Re: Geotechnical Investigation  
Mitigation for Potential Slope Instability  
15 Wood Lane (APN 002-081-07)  
Fairfax, California

Re: Geotechnical Response to Planning Department Comments  
15 Wood Lane (APN 002-081-07) Improvements  
Fairfax, California

To: Linda Neal – Principal Planner

**SITE PLAN**

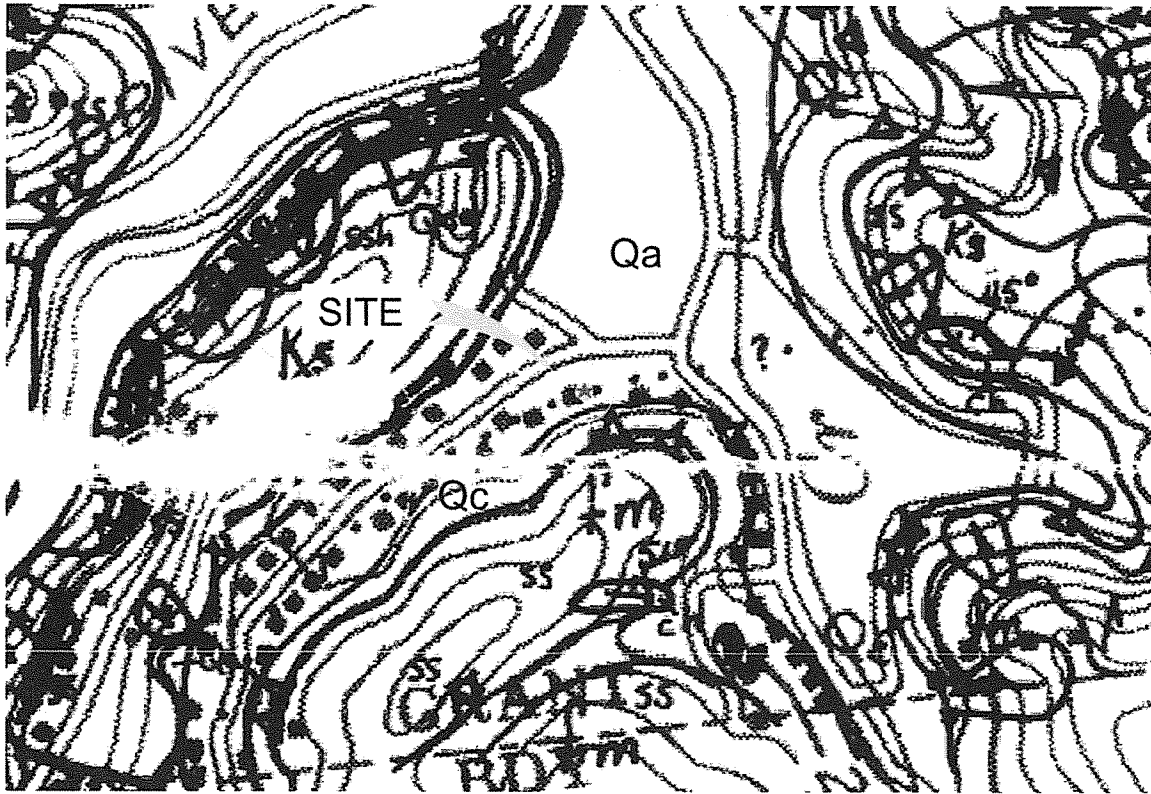
On page 8 of the Miller Pacific, 6/24/14, investigation report it states, in the third paragraph, “---areas between the location of Boring 2 and the south property line are judged to have moderate to high potential for slope instability, ---“. In paragraph four it states “The most significant threat to the residence is posed by debris flows originating high on the slopes beyond the southern property line ---“. The report goes on in significant conceptual detail on how to deal with these slope stability problems.

Due to gently sloping grades, we judge that there is generally little risk of instability in areas north of Boring 2 as shown on Figure 2. The steeper, terraced areas between the location of Boring 2 and the south property line are judged to have moderate to high potential for slope instability, although since the upper mantle of porous, debris flow-prone colluvium has been largely removed by previous grading, instability in this area is anticipated to consist mainly of "creep" and more localized sloughing and raveling. These modes of instability may result in the periodic need for debris removal from the base of slopes, but are not likely to significantly impact the residence. We judge the likelihood of debris flows originating within the property boundaries is generally low.

**TYPICAL DETAIL TRENCH SUBDRAIN**

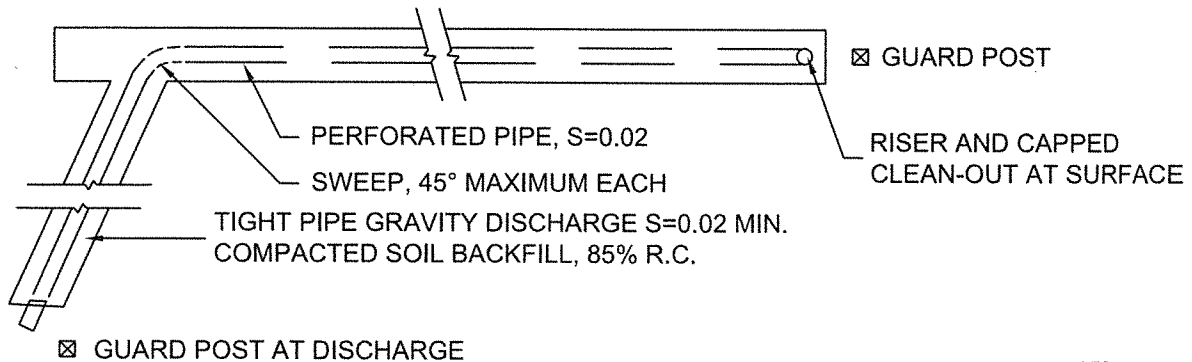
The concrete ditch, along the project site southerly property line, called for in the 6/24/14 report will be on weak soil at the top of a steep cut bank. This weak soil will likely creep downhill resulting in the concrete ditch cracking and failing. Design criteria must be provided to prevent creep movement failure of this ditch. Topography map information must be provided for the area where the above drainage improvements will be placed, uphill of the southerly property line, so the location of the work and the affect of the work on existing trees can be shown. 100 year storm flow drainage calculations, at the construction permit review stage of the project, are required to show the stormwater flow quantity and conduit sizing to get the flow down the hill to the house yard area. A drainage easement must be provided for this flow transmission from Barker Avenue and down through this site.

The above drainage improvements may affect future development of Barker Avenue for access to the property above Barker Avenue. The design proposed must show that it minimizes access use problems for future development of Barker avenue.

We recommend that, at a minimum, subdrainage be provided on the slope above the southern property line, generally consisting of perforated pipes in a gravel-filled trench as detailed on Figures 4 and 5. Drains should be laid out in a "herringbone" shape, with the main collector pipe running down the fall line of the slope, roughly in the center of the swale. At the base of the subdrain system, near the south property line, the perforated pipe should transition to a solid discharge pipe and the gravel trench should be provided with a compacted clay or controlled-density fill (CDF) check dam. The solid discharge line should extend downslope and convey runoff into an established storm drain system.

OPTION 1 - INTEGRATED DEBRIS CATCHMENT WALL

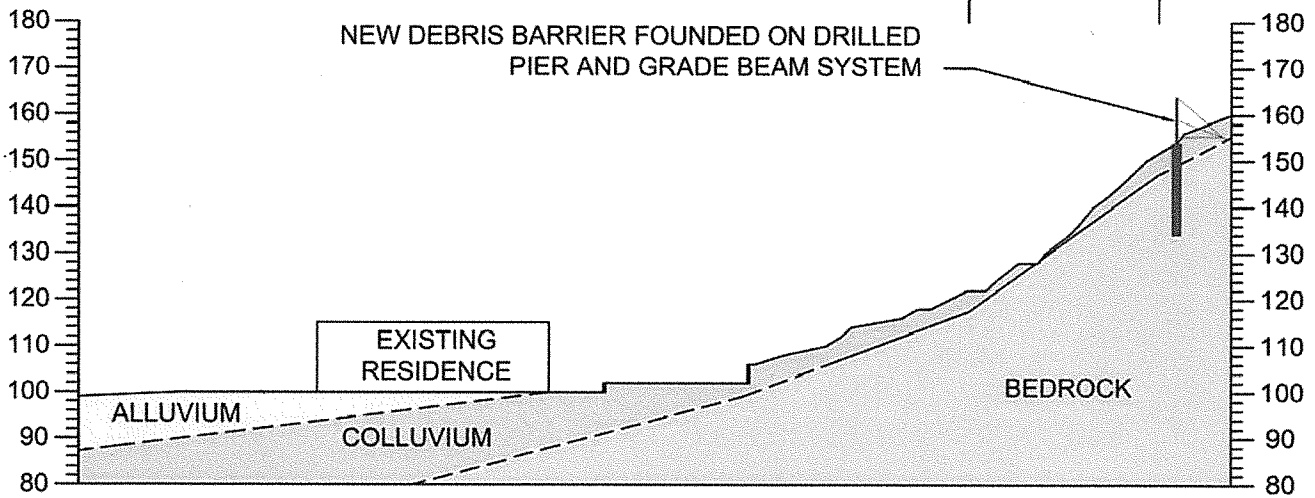
the Town as part of any mitigation submittal, will have no significant effect on slope stability, will not reduce the risk of debris-flow initiation, and will not provide any meaningful improvement either in protection of life safety or in protection from structural damage in the event of a debris-flow. Therefore, we judge that, if the interest is protecting life safety and protecting the residence from structural collapse to minimize economic dislocation from geological hazards, then the integrated debris-catchment wall is sufficient to accomplish these purposes. Construction of any new drainage improvements within the property limits is not warranted or necessary at this time". The above quote discusses a non-existent Town design request for drainage within the property and it does not resolve the drainage issue. We need to, again, go back to the 6/24/2014 Miller Pacific report. Drainage is discussed in other parts of the report but the paragraph on page 9, under Geotechnical Site Drainage Recommendations is a good reference. It states "Since soil saturation commonly contributes to slope instability, providing adequate surface and subsurface drainage provisions is paramount to improving overall stability. Since the highest risk is posed by instability originating offsite to the south, it is recommended that the adjacent property owner, believed to be to Town of Fairfax, be consulted regarding the potential for construction of new drainage improvements by mutual agreement, creation of an easement, or other means". The report goes on to describe additional, "at a minimum" drainage improvements including drainage within the property limits. The need for drainage improvements above the southern property line (outside the building site property limits) and within the property limits is clearly defined in the 6/24/2014 report. This need for drainage improvements, required in the 6/24/2014 Miller Pacific Report, cannot be ignored and must be resolved. The Town has asked for the resolution of the drainage improvement requirement by having that drainage work shown on the plans that will be provided for Planning Commission review. I will restate that it has been determined that the Town is not the owner of the land above the southern property line (noted in the 6/24/2014 report).

The statements in the 10/14/2014 addendum appear to indicate that drainage improvements said to have been requested by the Town to be placed within the property are not needed. The Town did not request such improvements. What must be resolved is the very specific requirement in the 6/24/2014 report for drainage improvement southerly of this building site property line and drainage improvements within this site's property lines. The Town has suggested that the Miller Pacific Engineering Group may, after further consideration beyond the 6/24/2014 report, be able to provide justification for not constructing the drainage improvement they recommended in that report. If the decision is reached by this consultant, that the recommended drainage is not required and the Town receives a properly signed and sealed letter from the consultant that clearly and reasonably describes why those drainage improvements are not needed, then the Town may agree that the drainage improvements are not a required part of the project.

Option 1 would entail integrating a debris catchment structure into the residence itself, where the rear exterior wall of the residence is designed as a catchment wall capable of withstanding debris impact as schematically shown on Figure 6. In this event, the rear wall of the residence would likely need to be constructed of reinforced concrete, and window/door placement and materials will require careful consideration by the project Structural Engineer and Architect. If windows and doors will remain as part of the rear catchment wall, cleanup of debris within the residence should be anticipated following a debris flow event, and no bedrooms should be allowed along the rear wall on the ground floor.

If this option is chosen, the rear exterior wall of the residence should be designed by the project Structural Engineer to withstand an equivalent fluid pressure of 200 pcf for a minimum height of 10-feet. Wall foundations should consist of drilled, cast-in-place concrete piers designed in accordance with the criteria shown in Table A.

As discussed in our previous Investigation report, the residence's new rear wall should be designed by a suitably qualified, licensed Structural Engineer to withstand debris impact having an equivalent fluid pressure of 200 pcf up to a height of at least 5-feet for the purpose of protecting the residence from structural collapse in the event of debris-flow impact. This may require "returns" or buttresses to some extent along the north and south exterior walls where they adjoin the planned catchment wall. Wall foundations could consist of drilled, cast-in-place concrete piers; alternatively, shallow foundations may be utilized provided sufficient lateral support can be achieved to resist sliding and overturning in the event of debris impact. Catchment wall foundations should be designed in accordance with the criteria shown in Table A.

As indicated in our previous Geotechnical Investigation report, it is our professional opinion that construction of the proposed integrated debris-catchment wall will result in a significant increase in protection of life safety for occupants of the residence and will also provide reasonable protection from structural collapse following impact from a possible, but uncertain, debris-flow event. It should be noted that the primary purpose of this integrated wall is to prevent structural collapse, and that some cosmetic damage and debris cleanup may be expected following a debris flow, depending on the extent and placement of apertures such as windows and doors. Additionally, no improvement in the protection of life safety for persons outside the structure will be realized in the event of a debris-flow.

Construction of the proposed integrated debris-catchment wall will not affect stability of the slope south of the residence, and will neither increase nor reduce the risk of debris-flow occurrence. In addition, it is our opinion that construction of new surface or subsurface drainage improvement within the property boundaries, as apparently requested by the Town as part of any mitigation submittal, will have no significant effect on slope stability, will not reduce the risk of debris-flow initiation, and will not provide any meaningful improvement either in protection of life safety or in protection from structural damage in the event of a debris-flow. Therefore, we judge that, if the interest is protecting life safety and protecting the residence from structural collapse to minimize economic dislocation from geological hazards, then the integrated debris-catchment wall is sufficient to accomplish these purposes. Construction of any new drainage improvements within the property limits is not warranted or necessary at this time.
